Applicant: Joel Livingood; Interlachen Country Club  
Consultant: Lindsey Roberts McKenzie; SEH, Inc.  
Project: Interlachen Country Club Golf Course Renovation  
Location: 6200 Interlachen Boulevard, Edina, MN  
Applicable Rule(s): 2, 3, 4, 5, 6, 10, 11 and 12  
Reviewer(s): Louise Heffernan; Barr Engineering Co.

# INTERLACHEN COUNTRY CLUB

SOUTHERN PART OF PROPERTY - DRAINAGE AND GRADING

**Figure 3.** Proposed drainpipe locations (shown in red).

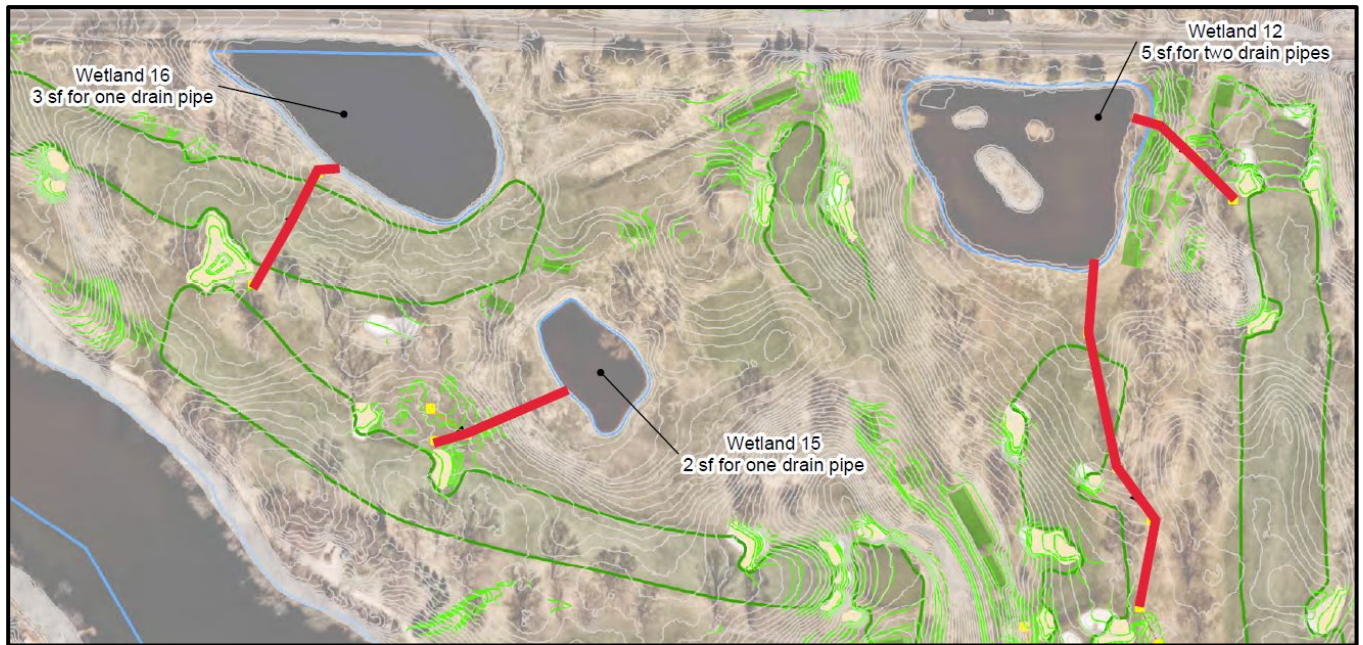
New 6-inch and 12-inch drainpipe is proposed to be installed in the bank or bed of Wetlands 12, 15 and 16 for the purpose of conveying stormwater runoff from depressions within the wetlands' drainage area boundaries.

Because impervious areas are not proposed to be increased within the site, subwatershed drainage areas or boundaries are not to be altered, an increase in additional stormwater runoff volume will not be generated (impervious area reduced), discharge rates from the site will be maintained and or reduced, and flood storage volume below the 100-year frequency flood elevation for each wetland will be maintained, the engineer finds that the installation of the drainpipes will not result in hydraulic capacity modifications or increases in the flood stage of the wetlands. The materials demonstrate and the engineer finds that the project is in conformance with subsection 6.3.1a criteria.

The project will not permanently change conditions in a manner that will deter wildlife from using the area adjacent to or within Wetlands 12, 15 and 16. Construction activities may temporarily displace wildlife until the area is restored to pre-project conditions. Revegetation plans provided by the applicant propose vegetative buffer for the riparian areas along the waterbodies to enhance ecological benefit and stabilization, as described in the **Rule 3.0 Wetlands Management** section of this report. Because wildlife native to the area will be able to continue using the vegetated area adjacent to and within the wetlands, the NMCWD engineer finds that the project is in compliance with subsection 6.3.1e criteria.

- No-build alternative: The elimination of the proposed drainpipes would result in excess stormwater runoff collection within isolated depressions throughout the wetlands' drainage areas, reducing the wetland hydrology. The applicant has asserted that the no-build alternative impacts the playability of the course with the desired frequency as a result of inundation throughout the course. The no-build alternative would result in inundation of depressions and low areas, which would require grading and fill placed below the flood elevations of the wetlands to eliminate pooling. The proposed drainpipe installation results in an inconsequential amount of material (<1 cubic yard per location) below the 100-year flood elevations of the wetlands for the placement of the drainpipes. The engineer finds that the no-build alternative and resultant placement of fill within the low areas/depressions would result in additional impacts (>1 cubic yard of material impacts). The engineer finds that the proposed design, in comparison to the no-build alternative, represents the minimal impact solution.

- Shorter drainpipe sections: The applicant evaluated shorter drainpipe installations at the discharge points into the wetlands, which would result in the installation of the 6-inch and 12-inch drainpipe sections above the bed or bank of the wetlands, thereby not triggering Rule 6.0 Waterbody Crossings and Structures. Installation of shorter pipe sections would result in concentrated flow down the banks of the wetlands and increase erosion potential to the resources. The engineer finds that the proposed design, in comparison to the shorter drainpipe sections, represents the minimal impact solution.

The applicant has demonstrated and the engineer finds that the proposed drainpipe configuration represents the minimal impact solution, based on evaluation of the alternative designs. The project is in conformance with subsection 6.3.1e criteria.

In accordance with the requirements of subsection 6.5 for the maintenance of the waterbody structures, the applicant must submit a draft declaration with NMCWD providing for maintenance of the drainpipe, then execute the agreement on approval of NMCWD.
